REMARKS

I. Objections to Drawings under 37 C.F.R. § 1.83(a)

FIG 1

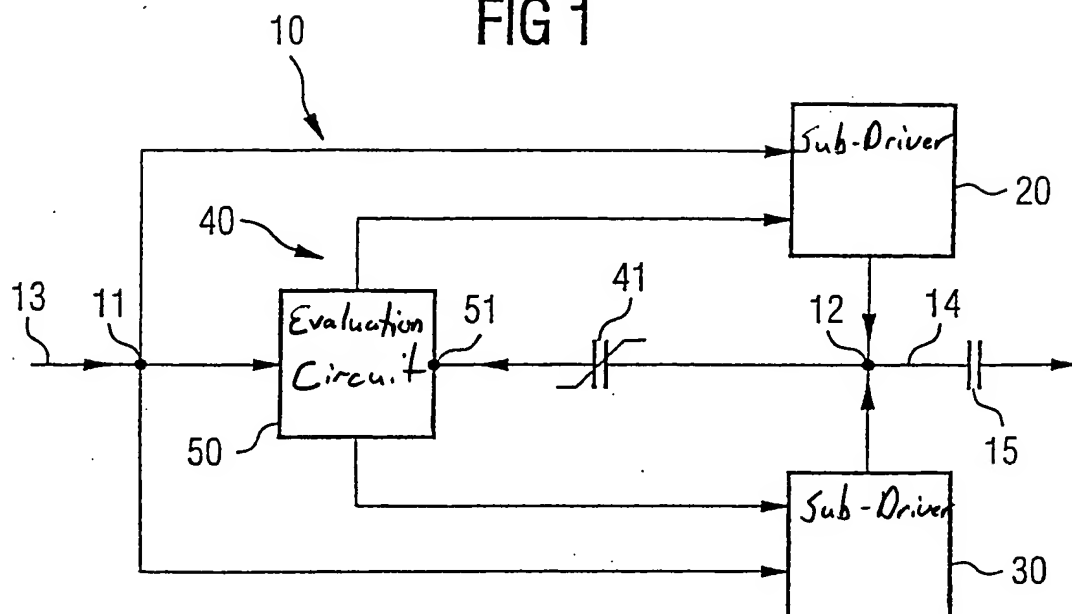
The Examiner also objected to Figures 1 and 3 "because the details in the two drawings are not compatible." In support of this position, the Examiner notes that "in figure 1, the evaluation circuit (50) receives signal (13) and the output signal from the output node (12)" and, "in figure 3, the evaluation circuit (50) receives only one input signal from node (12)." Applicants respectfully traverse this objection.

The Examiner objected to Figures 1 and 2 "because functional labels of the boxes are missing." Although Applicants disagree, Figures 1 and 2 have been amended in the proposed amendments attached to this Response to add "functional labels" to the boxes as suggested by the Examiner. Support for these "functional labels" may be found in the numerals associated with the "boxes" and the description of the "boxes" in the specification as filed. Therefore, Applicants respectfully submit that a continued objection to Figures 1 and 2 as unlabeled is improper.

Applicants respectfully submit that Figures 1 and 3 are compatible. The compatibility of Figures 1 and 3 has been clarified by the labeling of the input node feature in Figure 3 with the numeral "11" in the attached proposed drawings. As now numbered, Applicants submit that Figures 1 to 3 now more clearly show the inputs to evaluation circuit (50). Particularly, both Figures 1 and 3 illustrate an input node (11) to direct an input signal (13) signal to evaluation circuit (50) and an output node (12) to direct the output signal to evaluation circuit (50). Therefore, Applicants respectfully submit that a continued objection to Figures 1 and 3 as incompatible is improper.
